This amendment revises the Technical Specifications to incorporate the updated reactor pressure vessel pressure-temperature limits, minimum boltup temperature, and reactor vessel capsule withdrawal schedule as required by 10 CFR 50, Appendices G and H.

DUANE ARNOLD ENERGY CENTER

Amendment No. 121
License No. DPR-49

SAFETY EVALUATION BY THE OFFICE OF NUCLEAR REACTOR REGULATION

Figure 3.6-1. Pressure versus Minimum Temperature Valid to Twelve Full Power Years, per Appendix G of 10CFR50

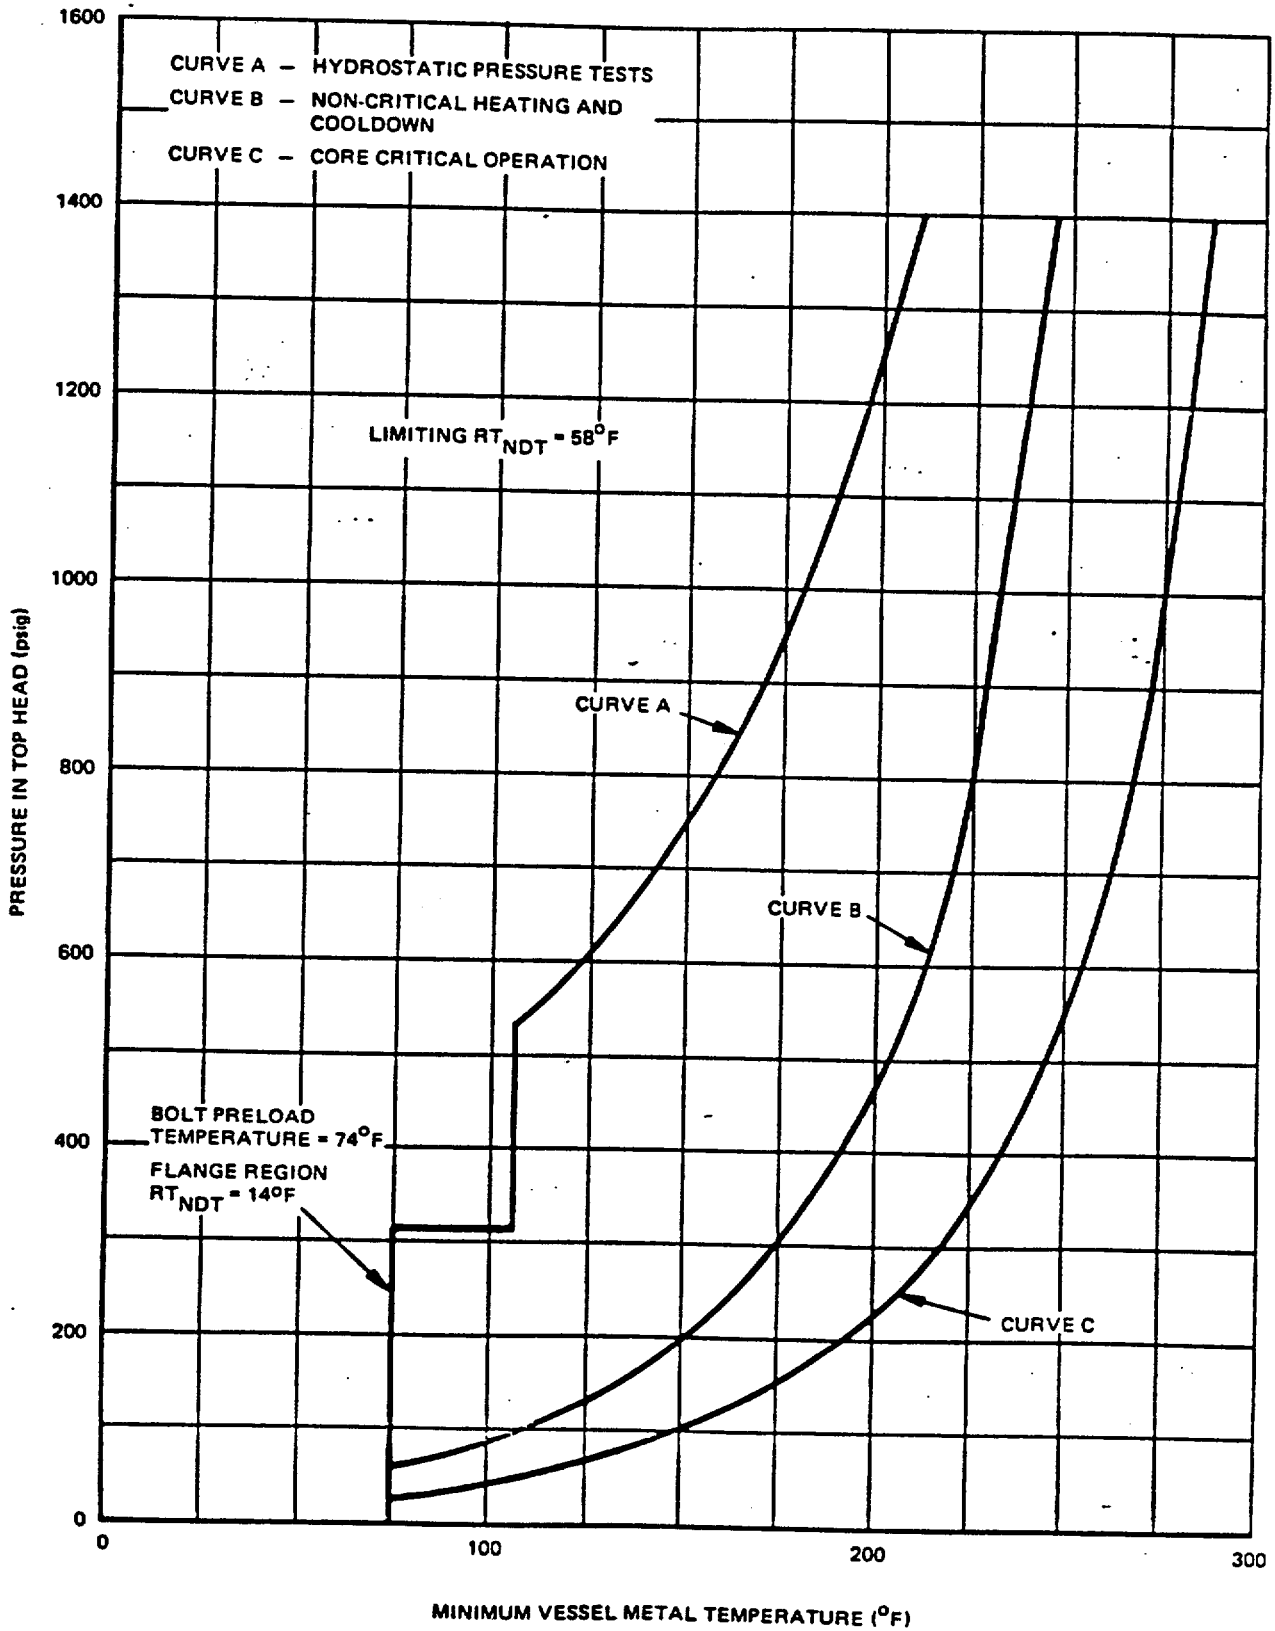
The operating limits in Figure 3.6-1 are derived in accordance with 10 CFR 50 Appendix G, May 1983 and Appendix G of the ASME Code. Conditions in three regions influence the curves: the closure flange region, the non-beltline region which includes most nozzles and discontinuities, and the beltline region which is irradiated with fluence above 10^{17} n/cm² during the vessel operating life. Irradiation causes an increase in the nil-ductility temperature (RT_{NDT}) of the beltline materials, possibly to the point where the beltline region impacts the pressure-temperature limits for the vessel. However, for Figure 3.6-1, effective to 12 EFPY, the beltline which has an

RT_{NDT} of 40°F is less limiting than the non-beltline regions which generally experience higher stresses at nozzles and discontinuities. The limiting RT_{NDT} of 58°F for the Standby Liquid Control Nozzle (N10) is the highest RT_{NDT} of any component in the non-beltline region.

Neutron flux wires and samples of vessel material are installed in the reactor vessel adjacent to the vessel wall at the core midplane level. The wires and samples will be removed and tested according to 10 CFR 50 Appendix H. Results of these analyses will be used to adjust Figure 3.6-1 as appropriate.

The staff used the method of calculating pressure-temperature limits in US NRC Standard Review Plan 5.3.2, NUREG-0800, Rev. 1, July 1981 to determine the amount of time that the proposed pressure-temperature limits are effective. Our conclusion is that the proposed pressure-temperature limits meet the safety margins of Appendix G, 10 CFR 50 for 12 EFPY and may be incorporated into the plant's Technical Specifications.
